Well Name: PANAMA 13 FEDERAL	Well Location: T19S / R33E / SEC 13 / SESE / 32.6556396 / -103.6112768	County or Parish/State: LEA / NM
Well Number: 01	Type of Well: OIL WELL	Allottee or Tribe Name:
Lease Number: NMNM98193	Unit or CA Name:	Unit or CA Number:
US Well Number: 3002536850	Operator: EARTHSTONE OPERATING LLC

Sundry ID: 2896001

Type of Action: Plug and Abandonment

Proposed P&A Procedure

Current Configuration

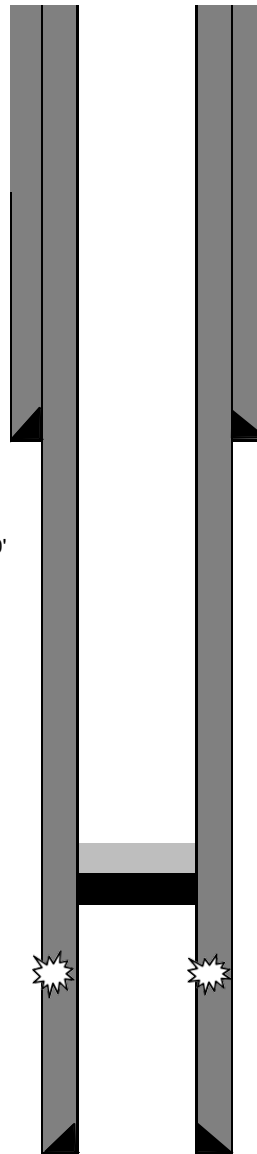
REVISED

Proposed P&A

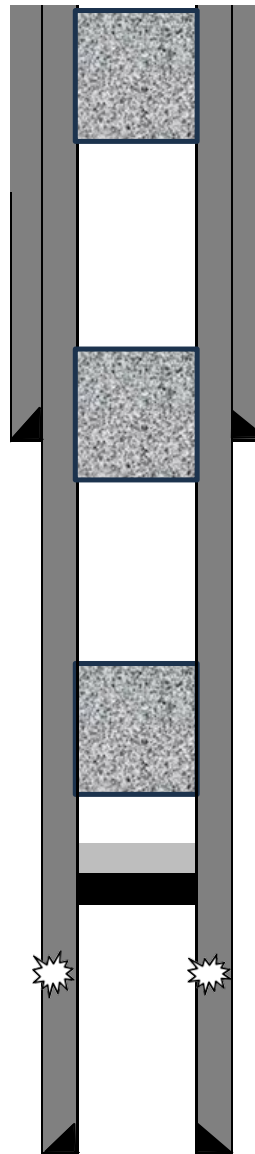
Plug #2: 1605' – 1400'
25 sxs Class C cement
WOC and Tag

Plug #1: 3394' – 2995'
27 sxs Class C cement
WOC and Tag

*Run CBL from CIBP to surface.

Submit results to BLM.

Tag CIBP and spot 25 sxs
on top.

REVISED
8:45 am, Mar 27, 2026

6. ND WH. NU BOP and function test BOP.
7. **Spot 25 sxs on top of CIBP.**
8. Pressure test casing to 500#. If casing does not test, then discuss with Regulatory for procedure change. If casing tests and MIRU wireline truck. Run CBL from CIBP to surface; hold 600 psi on casing if possible. Send an electronic copy of CBL to NMOCD representative. Results of CBL may change procedure; TOC on DWR.
